AMENDMENTS TO THE DRAWINGS

Appln. No. 09/552,590
Amend. Dated: 3/18/04
Reply to Office Action of 12/19/03
Replacement Sheet

FIG. 13

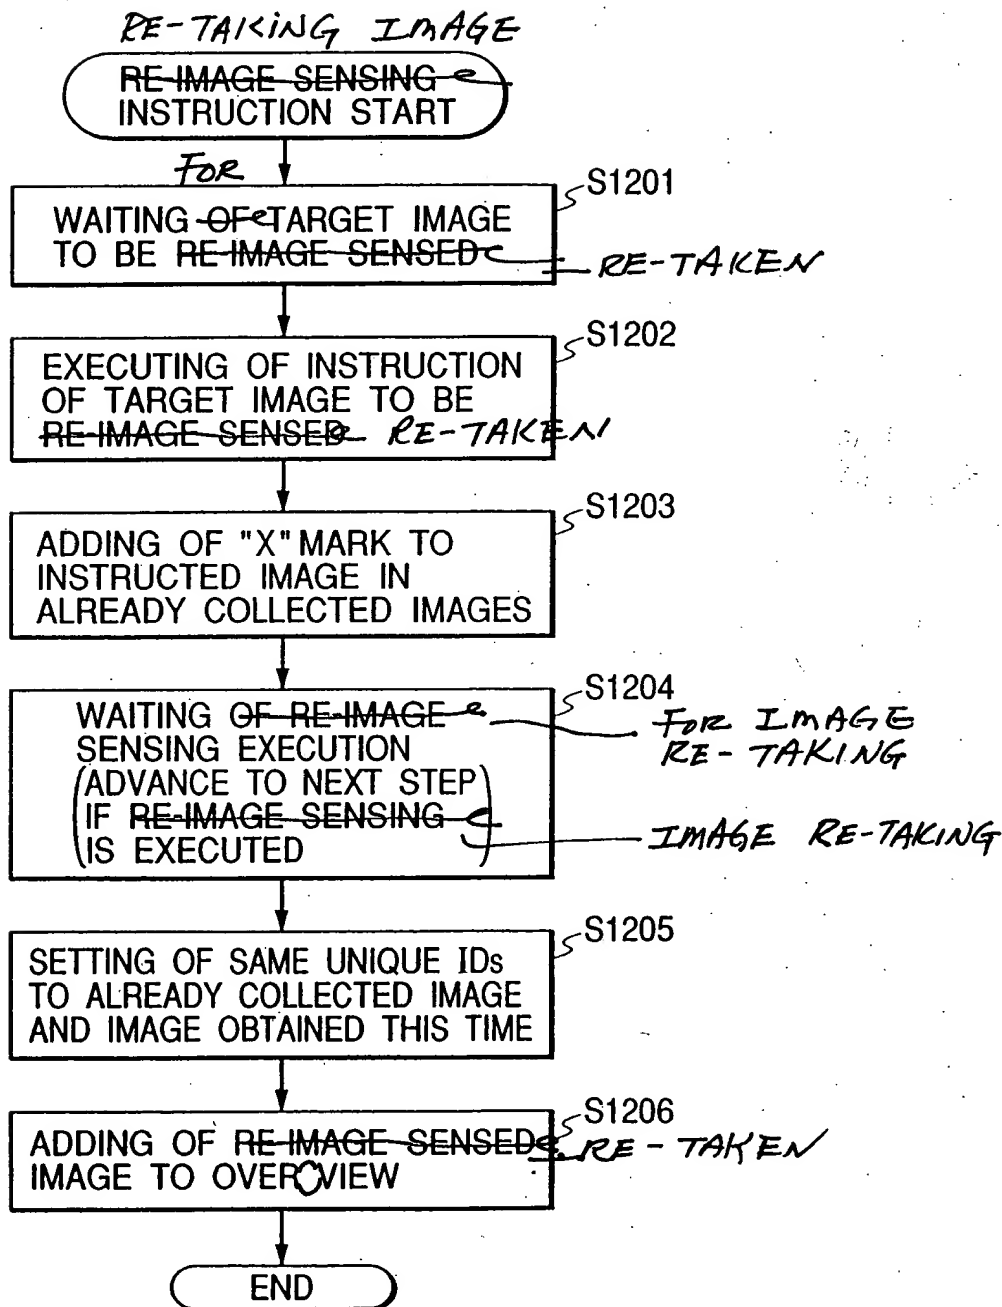
Fig. 13, change all occurrences of "OVER VIEW" to --OVERVIEW--.
